Office Action Summary	Application No. 10/058,029	Applicant(s) SASAKI, YOSHIYUKI	
	Examiner JORGE L. ORTIZ CRIADO	Art Unit 2627

DETAILED ACTION

The specification and the Drawings as originally filed provides for the user requesting the speed. See for example a portion of Applicant's originally filed Figure Drawing 6.

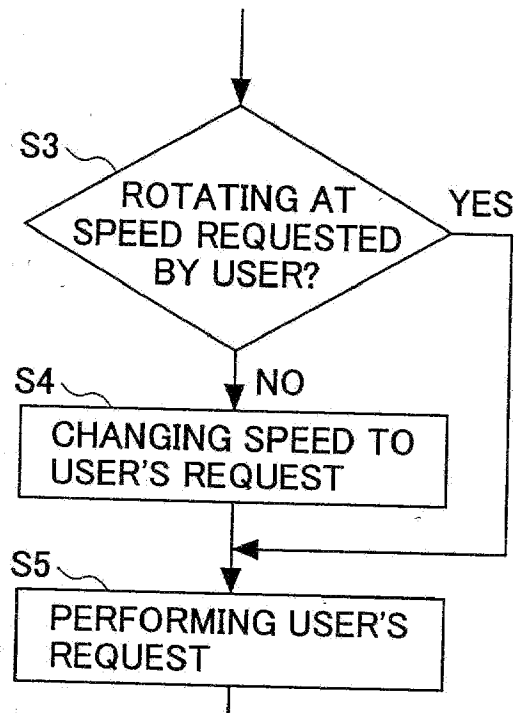
The Examiner cannot concur with the Applicant because the amendment to the drawings introduces subject matter of "determining if the first rotation mode is not suitable for the storing and reproducing of the user's request", which is not supported by the original disclosure.

However, contrary to the Applicant's assertion the Drawings as originally filed, and the specification, as originally filed, provides for whether the disc is rotating at a speed designated by the user, as outlined above.

As shown in the Figure step S3 expressly, clear and concise "rotating at speed requested by user" and further in step S4 "changing speed to user's request".
